ADDENDUM NO. 2 TO PROJECT NO. 44867

**CONSTRUCTION, HVAC, PLUMBING AND ELECTRICAL WORK
ADDITION TO DEMENTIA UNIT, MONTROSE VETERANS HOME
2090 ALBANY POST ROAD
MONTROSE, NY 10548**

December 23, 2013

MECHANICAL ROOM PLAN
 SCALE: 1/4" = 1'-0"

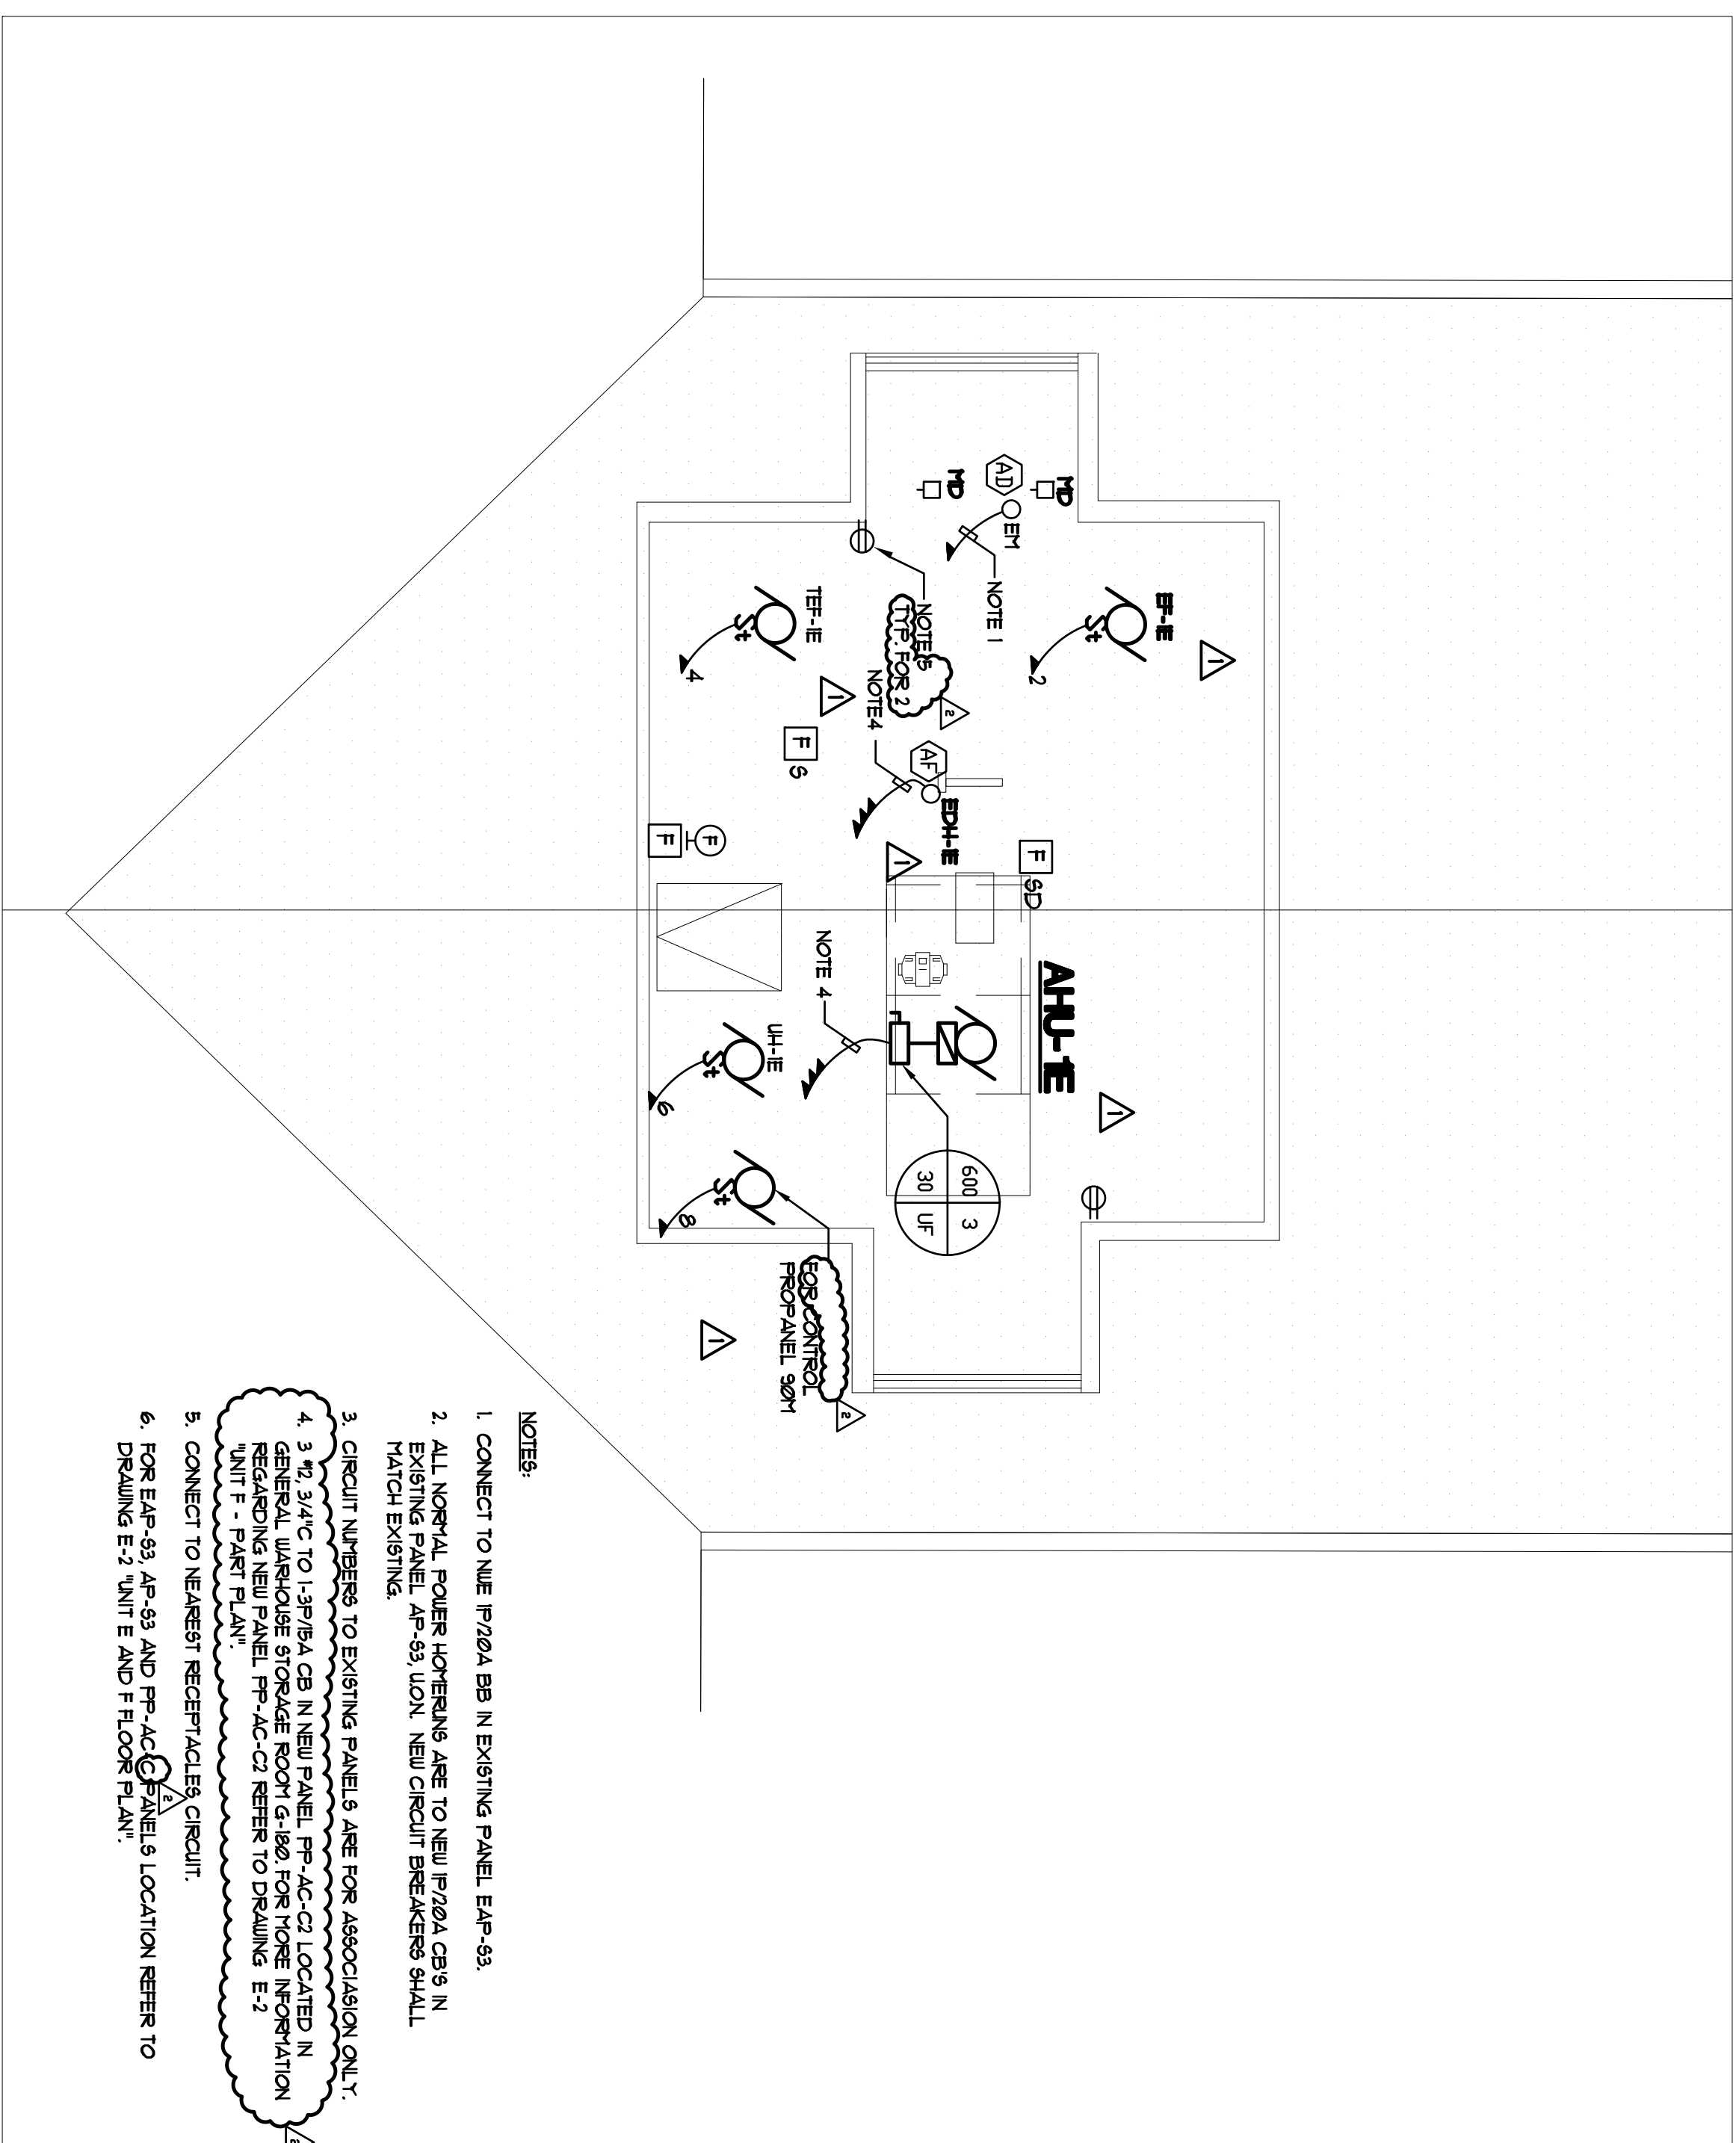
- a. Drawings Nos. E-2 and E-3, both noted “ADDENDUM 12/20/2013” accompany this Addendum and supersede the same numbered originally issued drawings.

DRAWING TITLE: RFI.14.EXPANSION.JT.

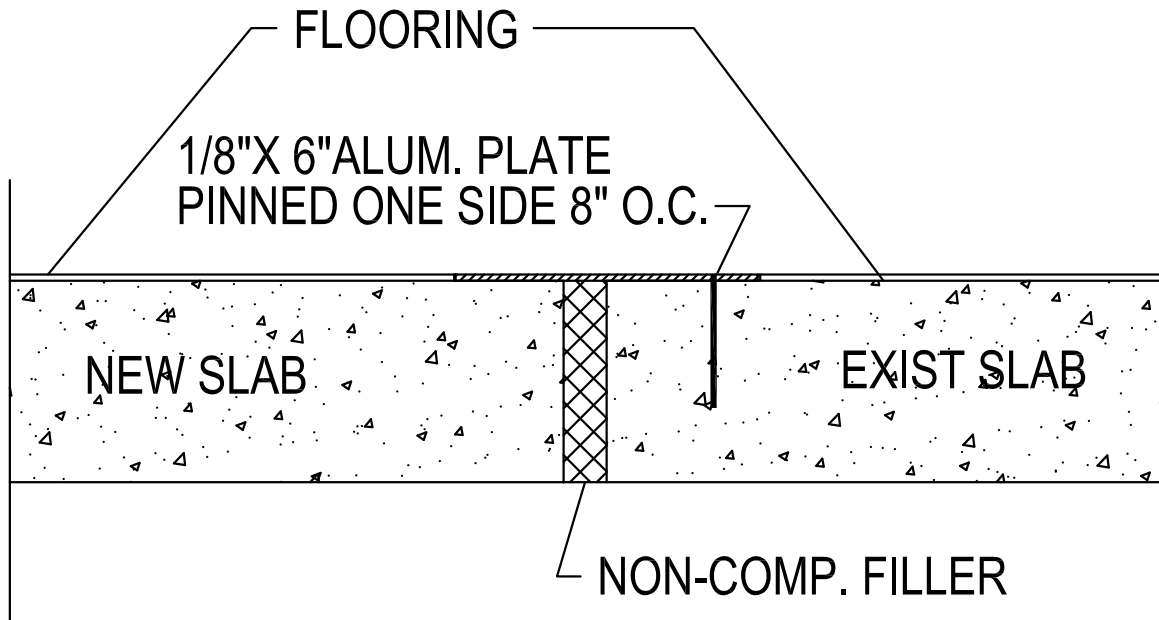
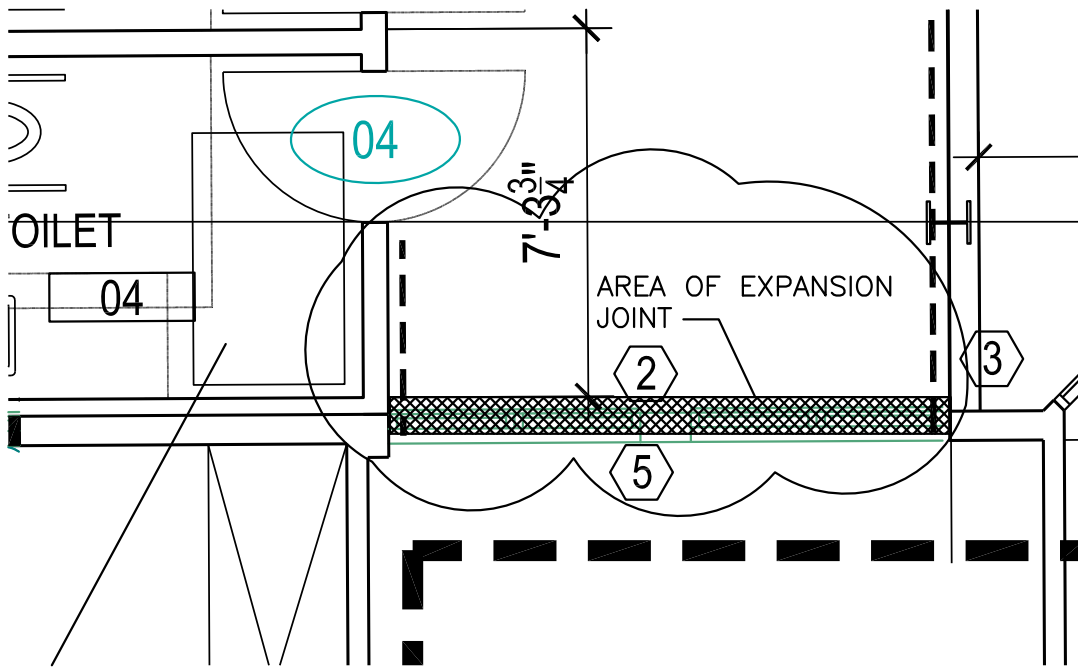
- a. Drawing No. 14 noted “RFI 14 EXPANSION JT and dated 12/06/2023” accompanies this Addendum and forms part of the Contract Documents.
